Recall Bulletin

PRODUCT SAFETY RECALL

SUBJECT: Shift Lever Indicator May Not Display Correct Gear

The Service Procedure section in this bulletin has been revised to include an inspection to determine if the clam shell has been installed on the transmission shift cable. Please discard all copies of bulletin 12106A.

3256032

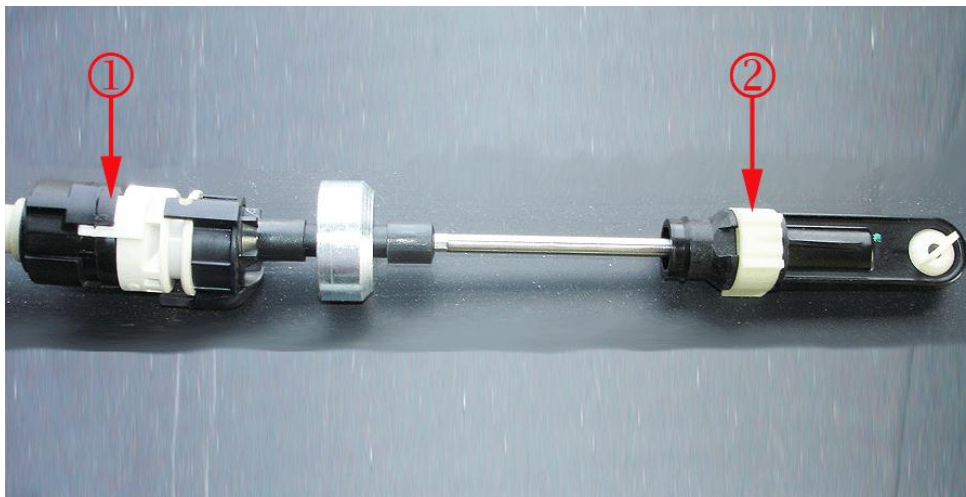
Note: Determine if field action bulletin 09041A has been completed. Inspect the shift cable for the presence of a clam shell cover that surrounds the shift cable locking tabs.

- If the clam shell cover is installed, no further action is required. Refer to the *Warranty Transaction Information* section of this bulletin. Submit a transaction using labor code V2743.
- If the clam shell cover is NOT installed, determine if the transmission shift cable is a first or second design cable.

2269486

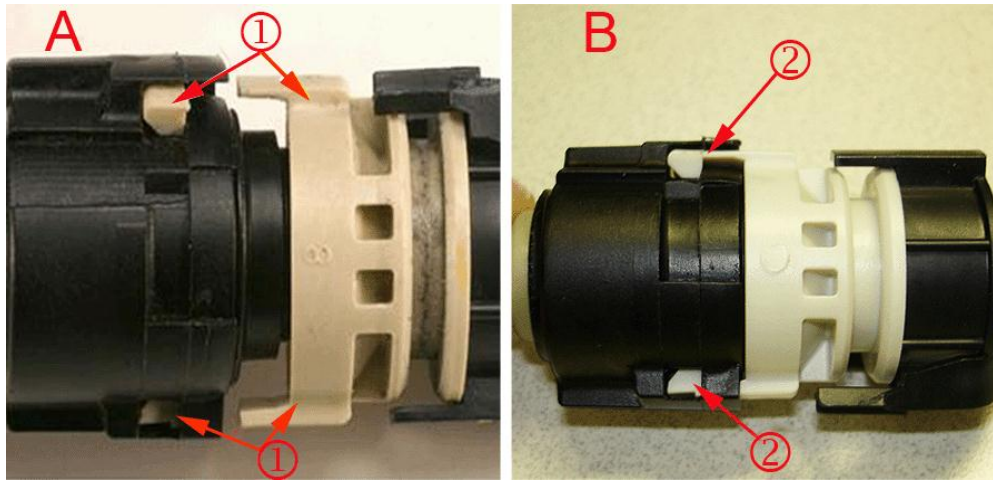
- (1) Shift Cable Locking Tabs
- (2) Shift Cable Adjuster Locking Clip

2. Determine if the transmission shift cable locking tabs are fractured and separated.

2269484

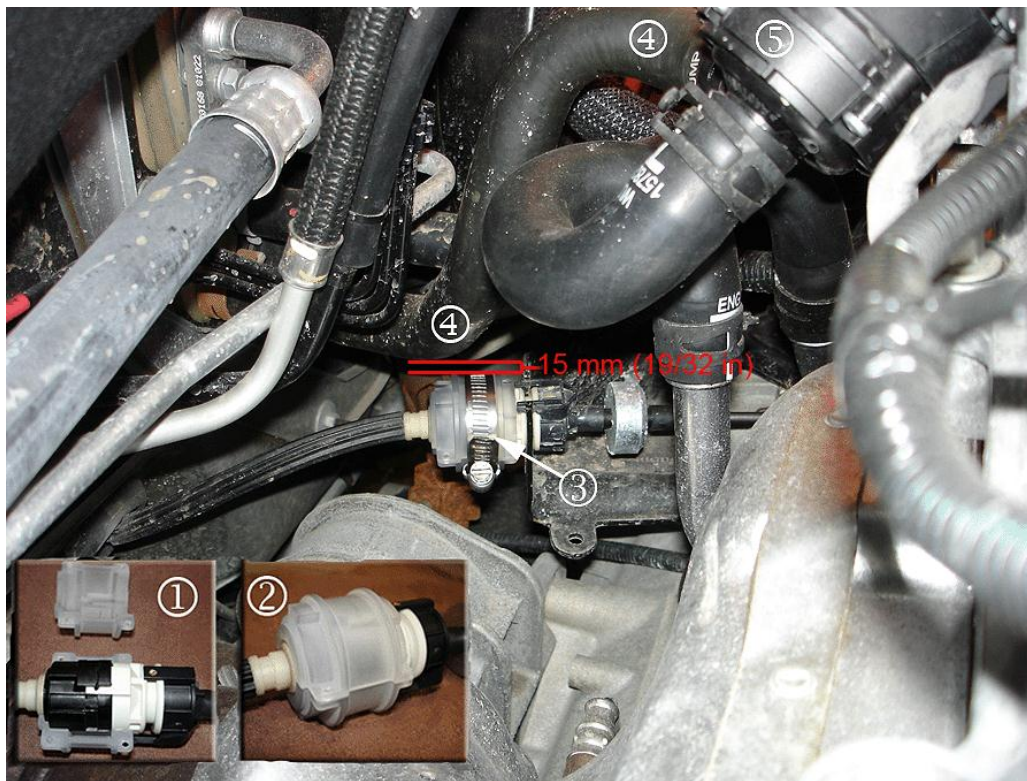
- If the transmission shift cable locking tabs (1) are fractured and separated (A), remove the transmission shift cable and replace it with a new one. Refer to *Floor Shift Control Cable Replacement or Range Selector Lever Cable Replacement* in SI. **Also install a transmission shift cable kit with the new shift cable.**
- If the transmission shift cable locking tabs (2) are NOT fractured and separated (B), install the transmission shift cable kit. Proceed to Step 3.

- (1) Clam Shell in Two Pieces
- (2) Clam Shell Around Shift Cable Locking Tabs
- (3) Clamp on Clam Shell
- (4) Inlet Coolant Hose and
- (5) Heater Cooler Pump.

3. Install the clam shell (1) (2) over the shifter cable locking tabs.
4. Install the service clamp over the clam shell (3). Position the clamp fastener head away from the inlet coolant hose (4). **Tighten the clamp to 4 N·m (35 lb-in).**
5. Ensure that there is 15 mm (19/32 in) of clearance between the inlet coolant hose (4) and the clam shell (3). On hybrid equipped vehicles, it may be necessary to reposition the inlet coolant hose (4) to achieve the required 15 mm (19/32 in) of clearance. **To reposition the inlet coolant hose (4) on hybrid equipped vehicles, locate the heater cooler pump (5) and perform Steps 5.1-5.4.**
